**METROPOLITAN DEVELOPMENT COMMISSION  
HEARING EXAMINER**

**Case Number:** 2024-CVR-855 / 2024-CPL-855

**Property Address:** 1527 East 12th Street (Approximate Address)

**Request:** Variance of Development Standards of the Consolidated Zoning and Subdivision Ordinance to build within 60 feet of the Stream Protection Corridor (not permitted).  
Approval of a Subdivision Plat to be known as Replat of Lot 29 in Milligan's Park Lane Addition, subdividing 1.878 acres into three (3) lots.

### VARIANCE REQUEST # 1

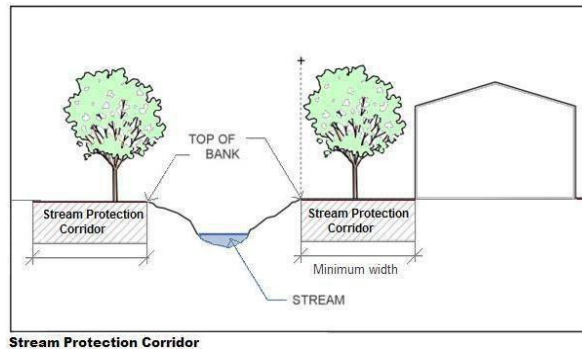
- **Request:** To provide for a detached single-family dwelling on proposed Lot 3, with a front building line of approximately 210 feet. (Front Building Line "Build to Range" 10'-19.9')
- **Ordinance:** Sec 744-701. C. Table 744-701-2.

Staff finds the property has a unique layout, a third of the subject parcel contains the Pogue's Runs Stream. The property features only one public street frontage, as the rest board two. The site benefits from natural amenities including the stream, and woods. Additionally, the property characteristics make aligning with the Infill Housing Guidelines difficult without the use of a variance in some manner. The petitioner's request to plat for three (3) lots represents a minimal density as opposed to the typical D-8 density. Given the property's unique conditions, which limit development options, staff recommends **approval** of the development standards variance.

Staff recommends **approval** of the Variance request to allow an increase in the front building line.

# Petitioner Exhibit B

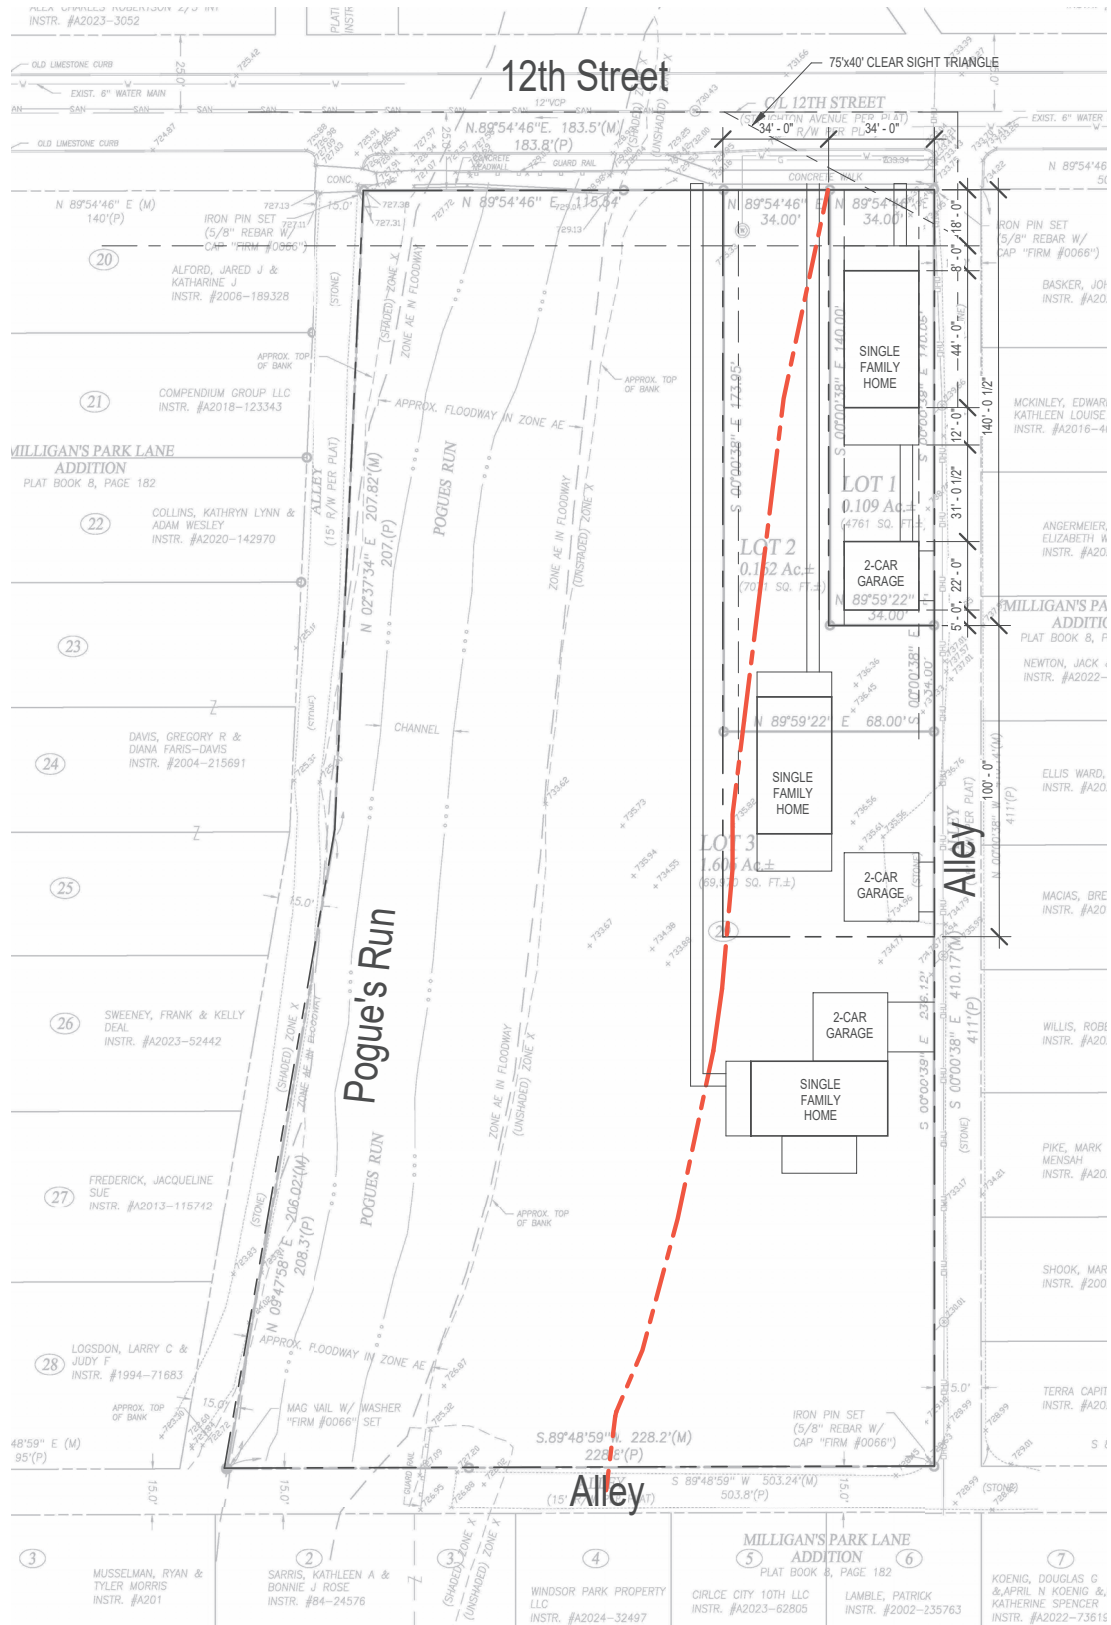
Staff recommends **denial** of the intrusion into the Stream Protection Corridor. There is no hardship as petitioner can still develop the property without intrusion. see Petitioner Exhibit B,

Staff recommends **denial** of the Variance request from to allow for construction in the stream protection corridor.
